Consultant Services Bulletin

News Bulletin No. 01-1, April 2001

**CONSULTANT NEWS BULLETIN 01-1**  
**TABLE OF CONTENTS**

**BRIDGE APPROACH SLAB  
AND TERMINAL JOINT**

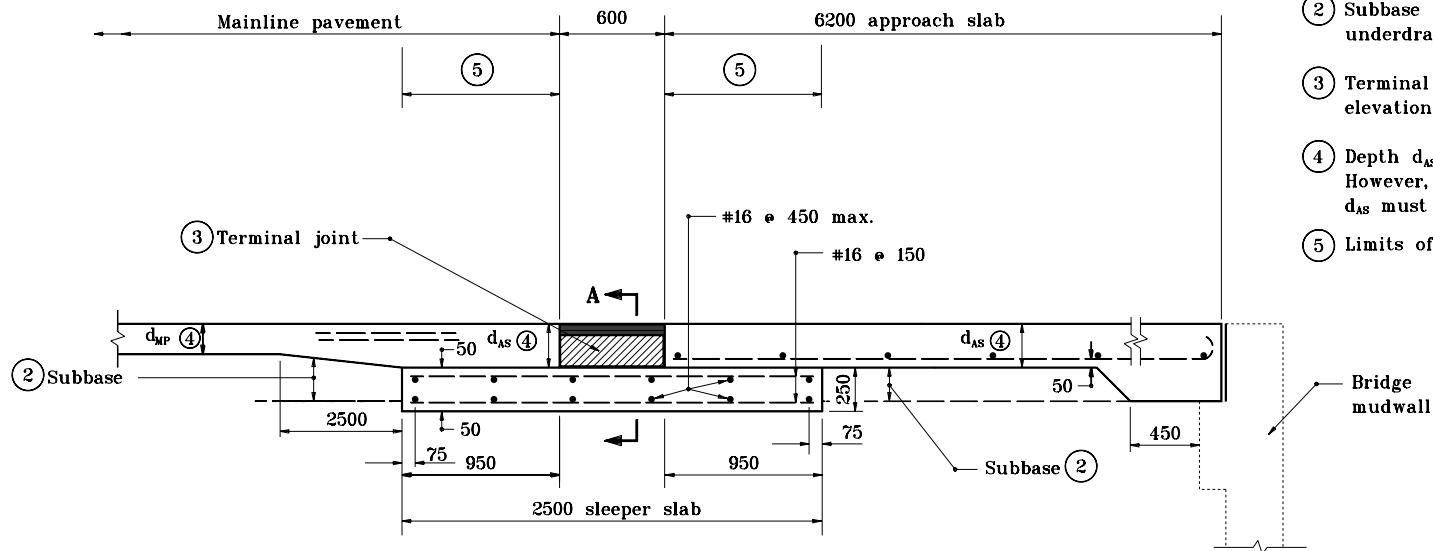
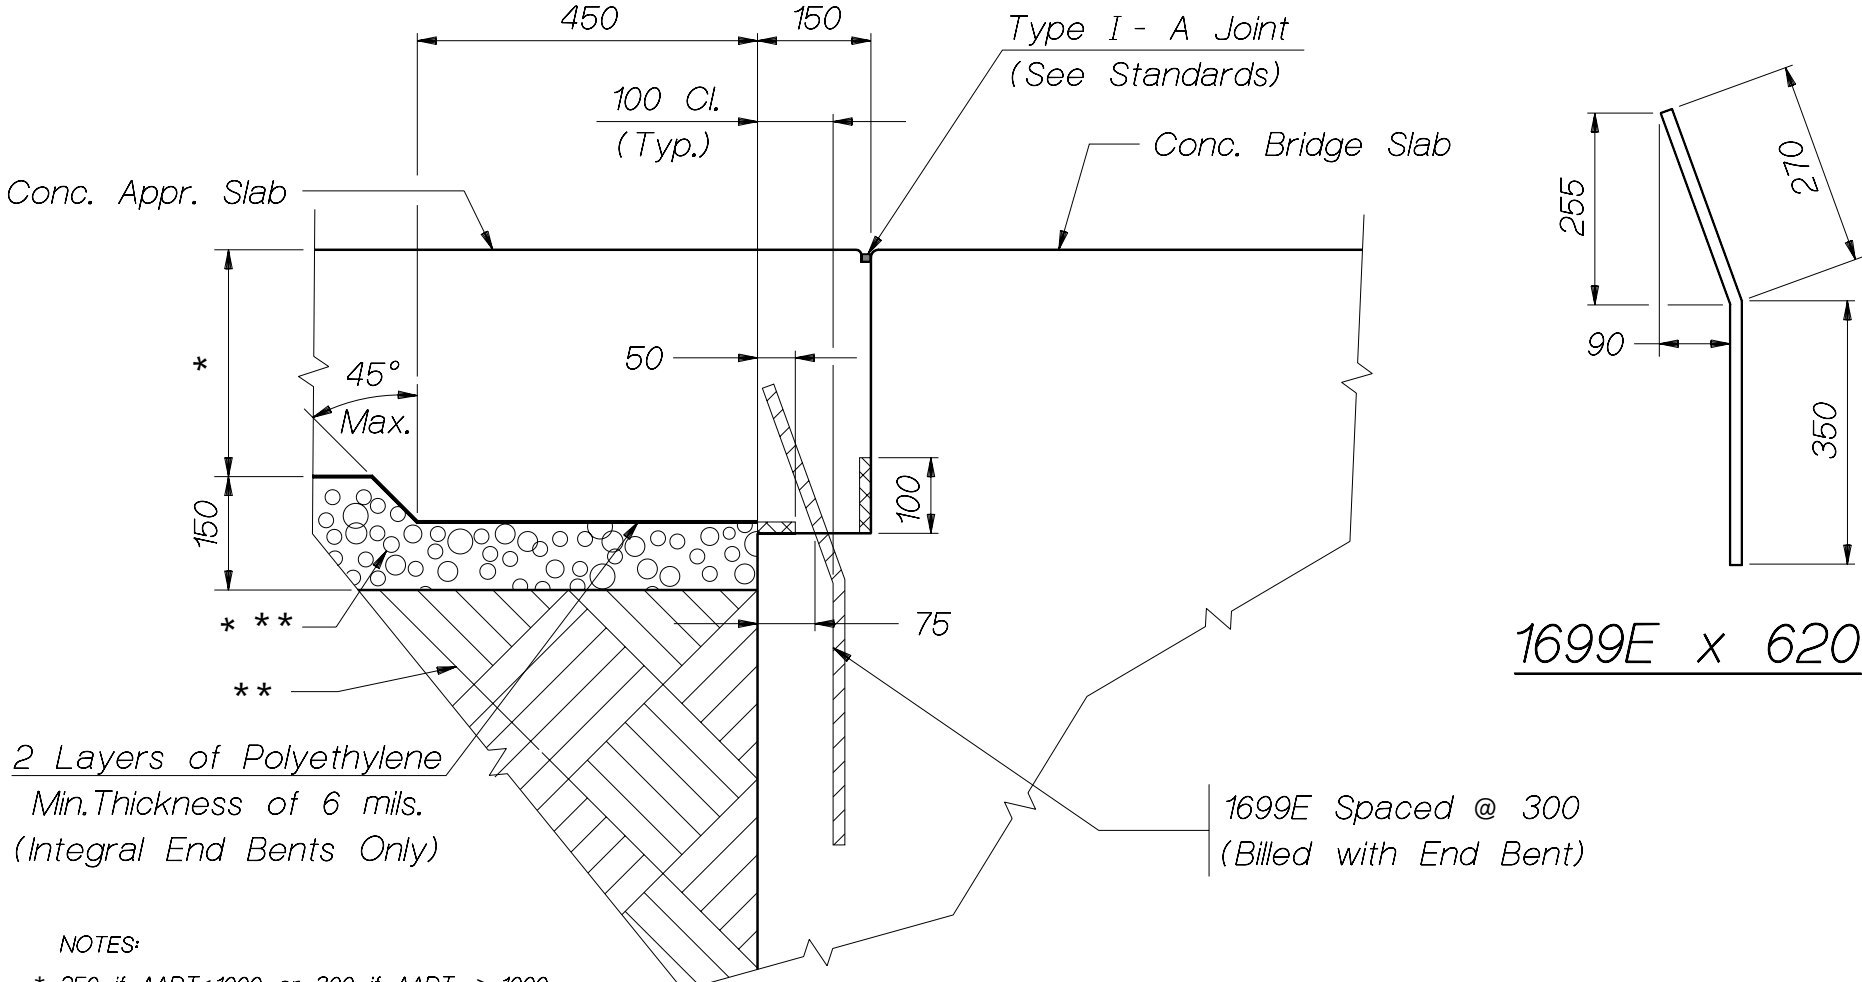
Revisions to 610-RCBA-01 and 610-RCBA-02 were approved during August 2000 by the Standard Specification Committee. By accident they were omitted from the September 2001 distribution of Standard Drawings. Therefore, the changes are being implemented by recurring special provisions 610-B-144d pages 1 and 2 or E 610-B-144d pages 1 and 2. The changes are:

1. The thickness of the approach slab will depend on the traffic count (250mm if  $AADT < 1000$  or 300mm if  $AADT \geq 1000$ ) if the approach pavement is all asphalt. See 610-B-144d page 1.
2. The thickness of the approach slab will be 300mm or the thickness of the concrete pavement adjacent to the approach slab. See 610-B-144d page 2.
3. The 45° taper of the approach slab thickness has been moved 450mm from the pavement ledge.

See Appendix "C" for the revised bridge approach slab details and for the revised pavement ledge detail which replaces the one published in Appendix "A" of Consultant Newsletter 00-1, dated February 2000.

- \* 250 if AADT < 1000 or 300 if AADT ≥ 1000  
or match thickness of concrete approach  
pavement (if thicker than 300)
- \*\* Flowable mortar if slab bridge or  
Coarse Aggregate #8 or #9 for all other bridges with end bents
- \*\*\* Comp. Aggr. Base Type "O" if no underdrains or  
Subbase for cement conc. pavement if underdrains are specified or existing
